Access Compliance Report Public Rights-of-Way (Curb Ramps)

Main Street: WHEELER_PL Cross Street: RAINIER_DR Location: SW

ADA ID: RPAT210930103009 Ramp Type: Type 1 - Perpendicular Diagonal Initial Pass/Fail: Fail Overall Compliance: No Severity Score: 0

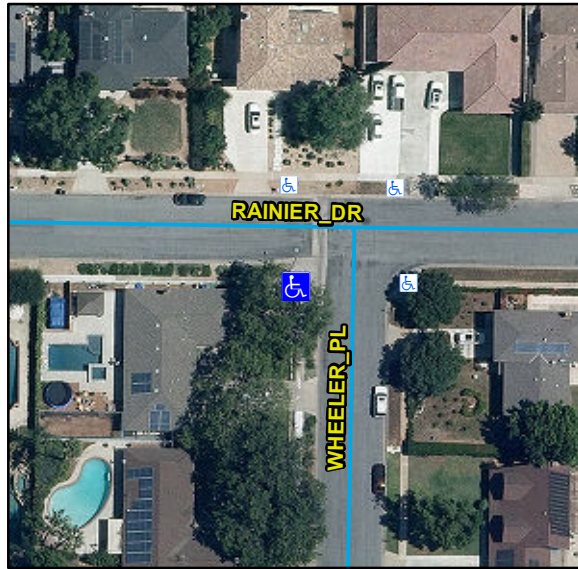
Compliance	Description	Data	Compliance	Description	Data
N/A	Ramp Length (in)	131	N/A	Flare Type LT	
Yes	Ramp Width (in)	63			N/A
Yes	Ramp Run Slope (%)	6.6	N/A	Flare Slope LT (%)	N/A
Yes	Ramp Cross Slope (%)	2.1	N/A	Flare Traversable LT	N/A
N/A	Landing Present	N/A	N/A	Flare Type RT	
N/A	Landing Length (in)	N/A			N/A
N/A	Landing Width (in)	N/A	N/A	Flare Slope RT (%)	N/A
N/A	Landing Run Slope (%)	N/A	N/A	Flare Traversable RT	N/A
N/A	Landing Cross Slope (%)	N/A	N/A	DWS Provided	N/A
N/A	Landing Movement Obstructed?	N/A	N/A	DWS Contrast	N/A
	Landing Movement Type	N/A	N/A	DWS Length (in)	N/A
N/A	Landing Shared	N/A	N/A	DWS Full Width	N/A
N/A	Clear Space	Yes	N/A	DWS Offset Left (in)	N/A
N/A	Clear Space To Crosswalk (in)	N/A	N/A	DWS Offset Right (in)	N/A
N/A	Marked Crosswalk 1	No	N/A	Marked Crosswalk 2	No
	Crossing 1 Direction	E		Crossing 2 Direction	N
	Marked Crosswalk 1 Width (in)	N/A		Marked Crosswalk 2 Width (in)	N/A

N/A	Ramp Inside Crosswalk 1	N/A	Yes	Ramp Inside Crosswalk 2	N/A
	Crossing 1 Slope (%)	6.2		Crossing 2 Slope (%)	4
	Crossing 1 Cross Slope (%)	0.9		Crossing 2 Cross Slope (%)	2.1
N/A	Gutter Ponding	N/A	No	Curb Slope	5.1
Yes	Gutter Lip Height (in)	0		Road Run Slope (%)	2.4
N/A	Gutter Run Slope (%)	N/A		Road Cross Slope (%)	0.6
N/A	Gutter Cross Slope (%)	N/A			
Yes	Overall Surface Condition: Acceptable		Yes	Perp Joint Present	Yes
	Cross Gutter Present?	Yes		Spandrel Present?	Yes
	Replace Cross Gutter?	No		Replace Spandrel?	No

Remove & Replace Curb Ramp With Two New Directional Ramps or Equivalent.
